Memo to the Planning Commission Discretionary Review

Case No.: 2016-005555DRP-02/VAR

Project Address: 1794-1798 FILBERT STREET/2902 OCTAVIA STREET

Revised 12 January 2016 1794-98 Filbert St., 2902 Octavia SFDBI Pre-App Letter

PRE-APPLICATION MEETING WITH SF BLDG DEPT

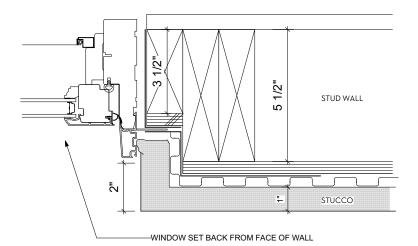
2. PLEASE CONFIRM THE PROPOSED PROJECT MAY HAVE ONE STAIR PER SECTION 102.12 (1). "The occupant load, number of dwelling units and exit access travel distance does not exceed the values in Table 1021.2(1) or 1021.2(2)."

Under Table 102.2(1), an R-2 building with one stair is possible up to three stories above grade plane, with 4 or less units if the Maximum exit access travel distance is 125 feet. Please see the note on the roof plan on Sheet 3 which shows 123' 11/2" travel distance to the exit stair. The most remote plan is shown on the roof deck.

One stair requires that the building be fully sprinklered. Please confirm this building will require a 13-R sprinkler system.

3. PLEASE CONFIRM OTHER FIRE RELATED REQUIREMENTS FOR THIS PROPOSED

4A. LU/LA ELEVATOR
We are asking for an exception for the elevator to accommodate a hospital stretcher. This is described under CBC 3002.4a Exception 5. "Elevators in buildings or structures less than four stories in height for which the local jurisdictional authority has granted an exception in the form of a written document." Would the smaller and more economical LU/LA Elevator be allowed for this proposed project?

5. PLEASE CONFIRM THE ELIMINATION OF ELEVATOR LOBBIES AT THE 2^{MO}
FLOOR, 3^{MO} FLOOR, AND ROOF DECK BY PROVIDING ADDITIONAL DOORS FOR SMOKE AND DRAFT CONTROL AT THE HOISTWAY.

6. MAY BEDROOM 2B HAVE ITS EGRESS WINDOW FACE THE REAR OF THE BUILDING?

Janice Hayes CORNICE AT BAY WINDOWS Please clarify the accessibility requirements for this project. Since the existing building is 3 units, can it be labeled "newly constructed" (102A)? If it isn't newly constructed, does a 3 unit apartment building need to meet accessibility requirements? Please confirm the Commercial space will need to follow accessible requirements in Chapter CORNICE AT CORNER BAY WINDOW The R-2 portion of the building (residential units) is exempt from Accessibility requirements. The M portion of the building (commercial space) will need to follow accessibility Janice Hayes NA 8. PLEASE CONFIRM A PROPERTY LINE WINDOW IS ALLOWED ALONG THE EAST FACADE per ABOO9. The window is completely above the neighbor's roof. It is not 6' above the neighbor's roof. Yes, the property line windows will be allowed. If the adjacent neighbor has any skylights, the new windows need to be 6' away from the skylights.

Yes, one stair as shown will comply. The roof deck is only accessed by the single unit on the top (Third) floor. The travel distance from the roof deck is correct and complies. If the roof deck was accessible by all the units, two stairs would be required.

No Manual Wet Standpipe will be required - this would be necessary if the building was a stories, but it is only 3 stories tall. Portable fire extinguishers would be voluntary in individuants, they are not required in common spaces. A fire alarm system will be required. Jeffrey Ma

An elevator is not required for this project because the building is existing and does not have an elevator. If the owner decides to put in an elevator, it may be a LU / LA Elevator, it may also be an even smaller residential elevator. A gurney elevator is not required per CBC 3002.e exception "5. Ean elevator is installed, it does NOT have to access all floors or all units. Jeffrey Ma Janice Hayes Janice Hayes WILL THE ELEVATOR BE REQUIRED TO GO TO THE ROOF DECK? -

The elevator is not required and not required to go to the roof deck if it is installed, see the answer to the question above.

There are two requirements for halls at the elevator. First is the lobby requirement and exceptions to this requirement that include smoke doors as a substitute. Second requirements is that the elevator may not open directly onto an exit enclosure. If the owner decides to install an elevator, there will need to be a hall (with a self-closing fire rated door at the first and second floors) to separate it from the exit enclosure.

Page 3 7 December 2015 Revised 12 January 2016 1794-98 Filbert St., 2902 Octavia SFDBI Pre-App Letter Information sheet E-02 references egress windows in R-3 occupancies facing rear yards less than 25'. This project is a R-2 occupancy. No. There is no egress path to the right of way from a window facing the rear. A light well at the rear of the building must be a minimum of 3' x 10' for any room with a required window facing the rear.
